**CITY OF SACRAMENTO**  
1231 I Street, Sacramento, CA 95814

**Site Address: 5929 61ST ST SAC**  
Parcel No: 027-0284-009

**Nature of Work: REMODEL OF BATHROOMS & CONVERT GARAGE TO LIVING SPACE**

CITY OF SACRAMENTO  
DEPARTMENT OF NEIGHBORHOODS, PLANNING AND DEVELOPMENT SERVICES  
BUILDING INSPECTIONS DIVISIONS  
RESIDENTIAL PLAN CHECK

**SISTER ANNA ROSA - 1/4"=1'0" - NEW FLOOR PLAN**

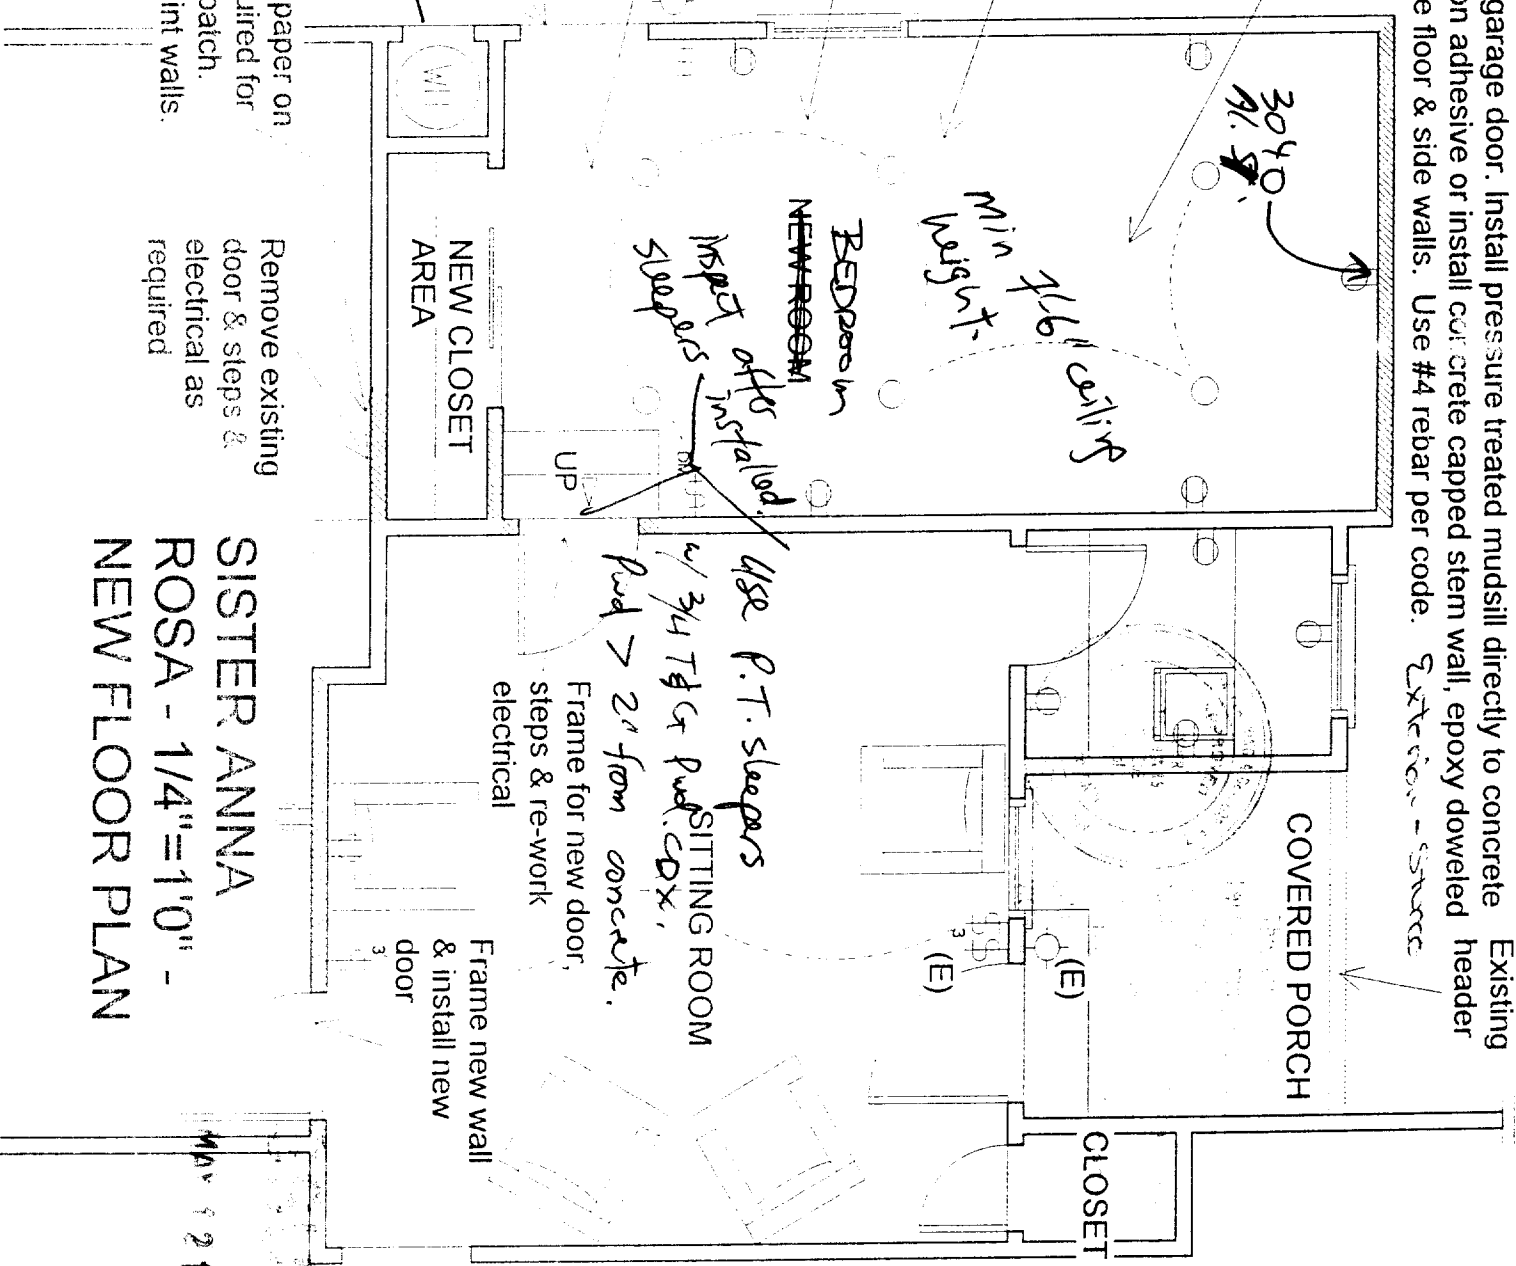
egress or rescue windows from sleeping rooms shall have a minimum net clear opening of 5.7 square feet. The minimum net clear opening height dimension shall be 24 inches. The minimum net clear opening width dimension shall be 20 inches. Where windows are utilized as a means of egress or rescue they shall have a finished sill height not more than 44 inches above the floor

*Revised by Mr. P.S. 5/12/99  
See file 29 +  
addl. inf. - attached*
